CITY OF WESTMINSTER			
PLANNING APPLICATIONS COMMITTEE	Date 17 November 2015	Classification For General Release	
Report of Director of Planning		Wards involved West End	
Subject of Report	9-11 Richmond Buildings, London, W1D 3HF		
Proposal	Demolition of the existing building and erection of a replacement building to provide sub-basements for use by a car stacker, and basement, lower ground, ground and first to fifth floor levels for use as residential accommodation comprising 13 residential units (Class C3). Creation of terraces at first to fifth floor levels and lightwells to the front and rear of the property. Installation of plant and PV cells at main roof level and condenser units within an enclosure at ground floor level within the undercroft.		
Agent	Scott Brownrigg Planning		
On behalf of	Almondbox Property Limited		
Registered Number	15/02851/FULL	TP / PP No	TP/10829
Date of Application	31.03.2015	Date amended/ completed	24.08.2015

9-11 RICHMOND BUILDINGS, W1

2. SUMMARY

Drawing Title: Town Planning - Level B2

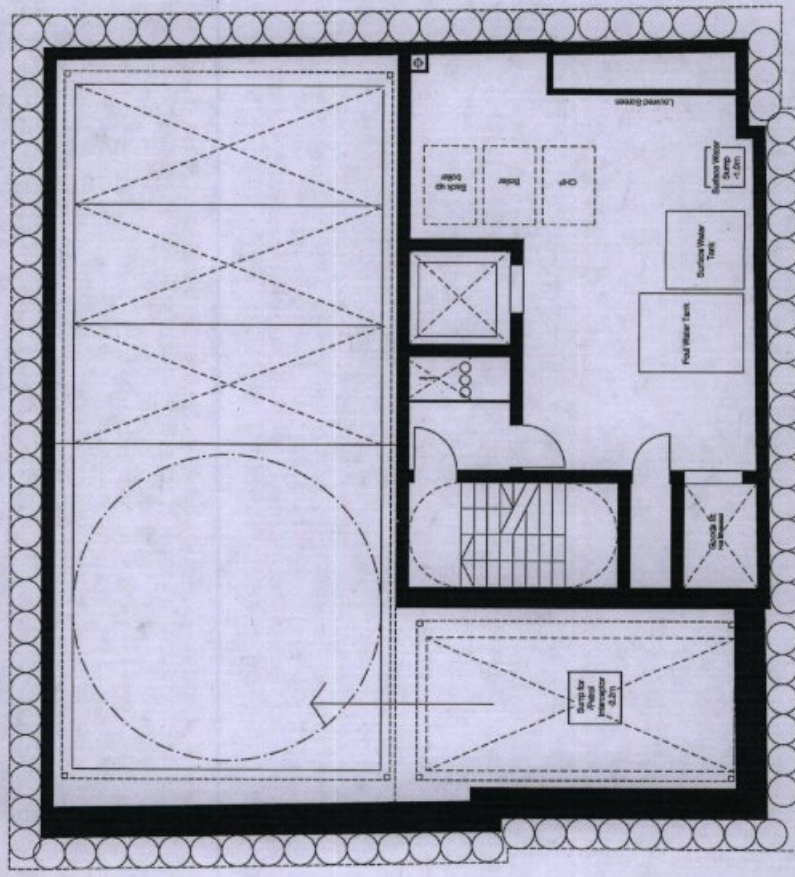
The amount of car parking proposed has been reduced from 13 to 8 spaces, for the 13 residential units (0.61 spaces per unit), using a stacker arrangement at sub-basement level. These would be accessed via a car lift in the same location as the existing vehicle access in Richmond Mews, with no change to the highway element. The applicant has indicated that the car parking spaces would not be allocated to a specific unit, and that this arrangement would be supported by car club membership. There is no waiting space proposed within the development site for a vehicle.

Drawing Title
Town Planning - Front Elevation

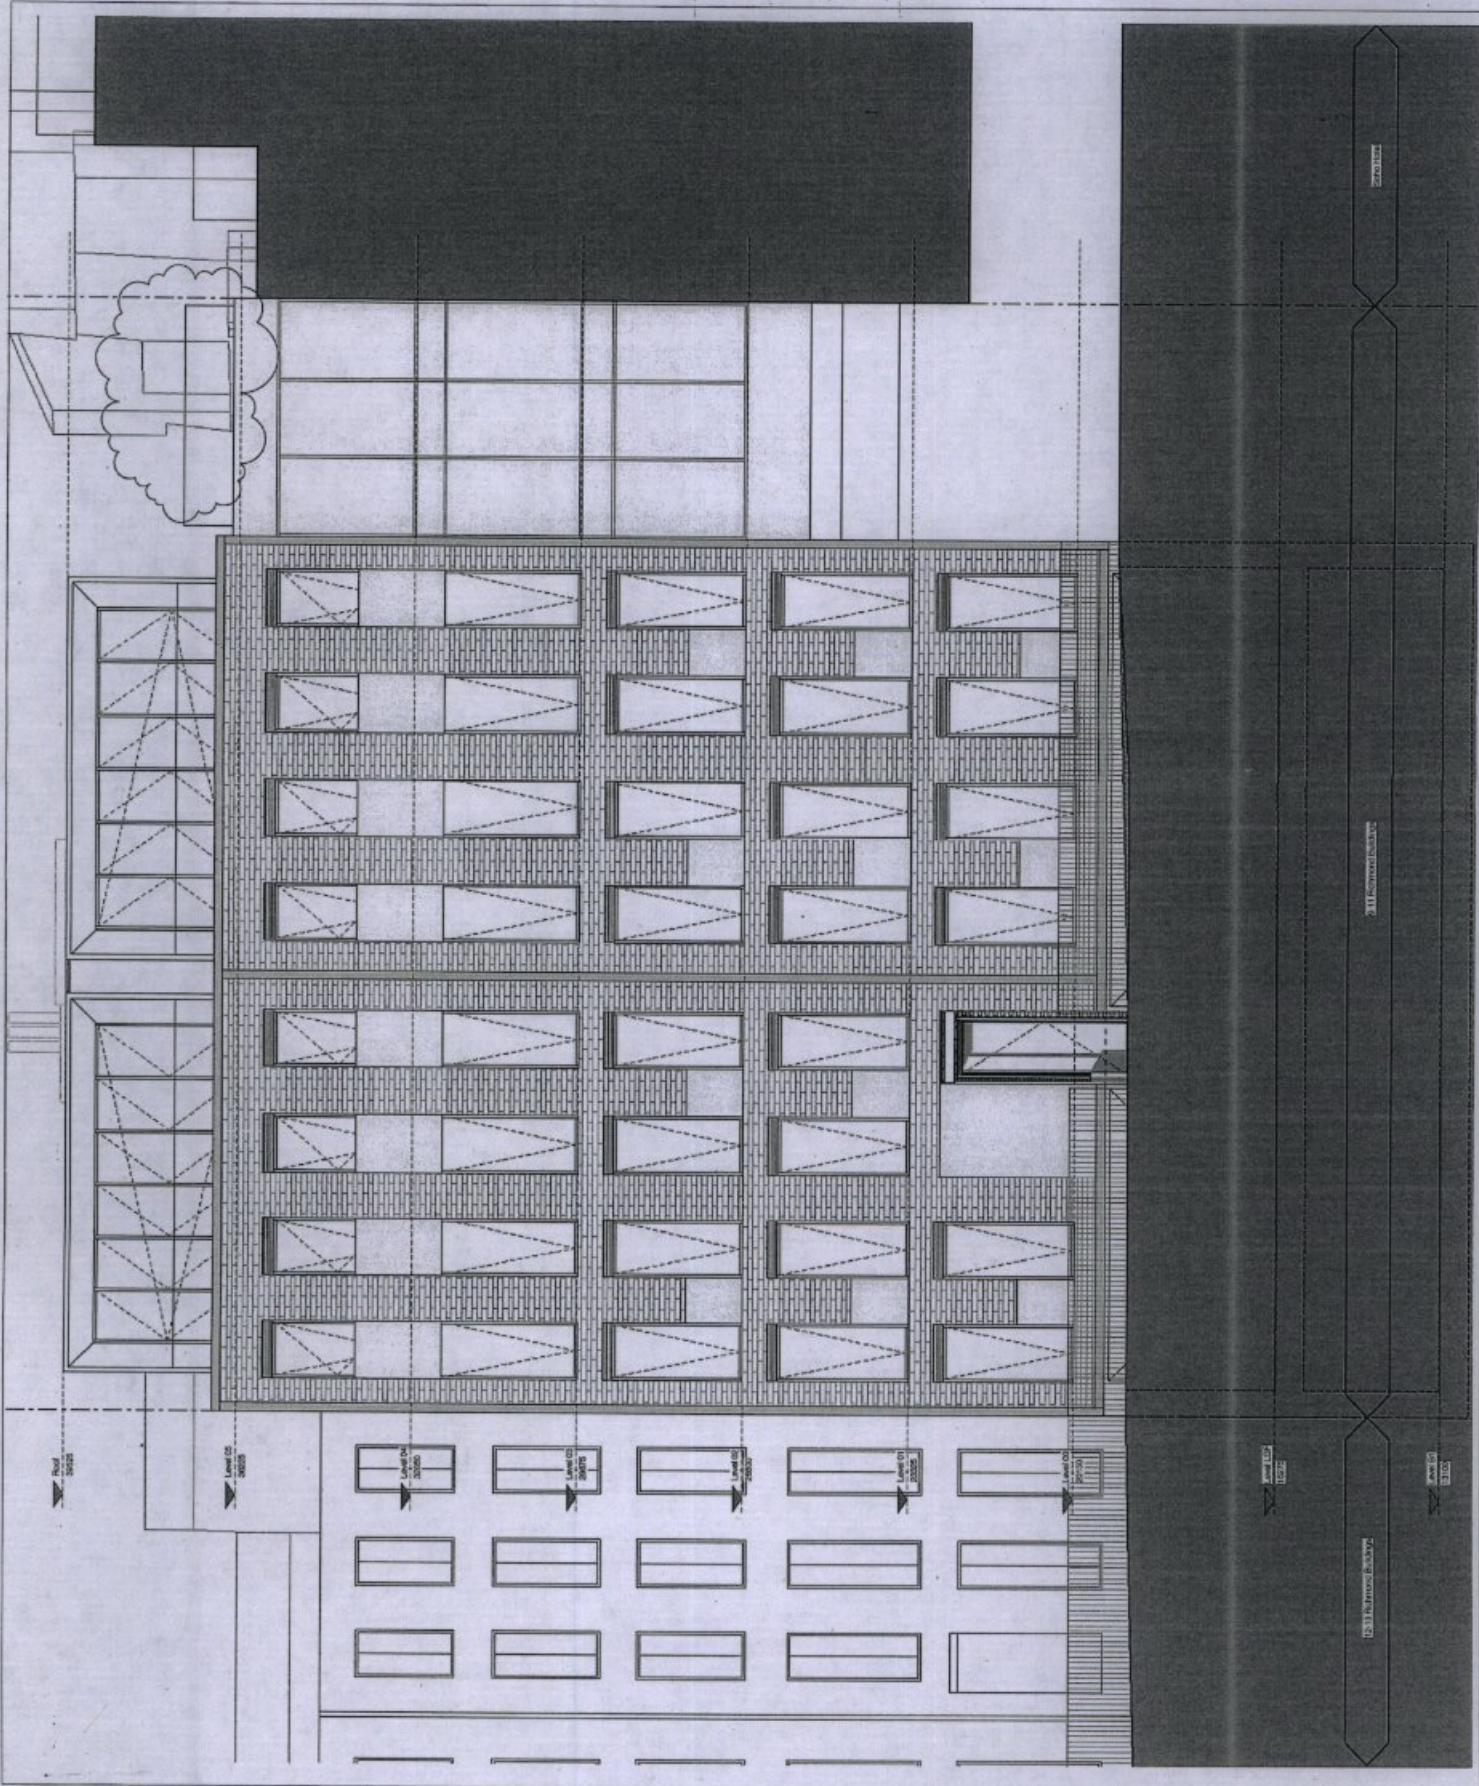
The street has been comprehensively redeveloped and no buildings of historic interest or architectural merit survive other than at the south east corner. The north side is occupied by buildings varying in height between three and six storeys and planning permission was recently granted to substantially alter the building on the corner of Dean Street (81-82 Dean Street and 3 Richmond Buildings) with the intention of minimising its apparent height and to remove the incongruous bay windows, which are not a characteristic feature of the conservation area. The south side of the street is also occupied by modern buildings, of four and five storeys, but the corner (80 Dean Street and 14 Richmond Buildings) is a much smaller and older scale of development and forms an important part of the setting of neighbouring listed buildings in Dean Street. Planning permission was recently approved for alterations and extensions at 12-13 Richmond Buildings which would see the replacement of the existing, vaguely historicist, facades with a carefully designed and skilfully detailed façade of elegant proportions.

The height of the main part of the building (excluding the small lift overrun) will increase by 5.6m (from 33.9m datum to 39.5m). Although the site does lie within the protected view from Parliament Hill to Palace of Westminster, the new building remains below the development plane of the strategic view and therefore there is no impact on this view.
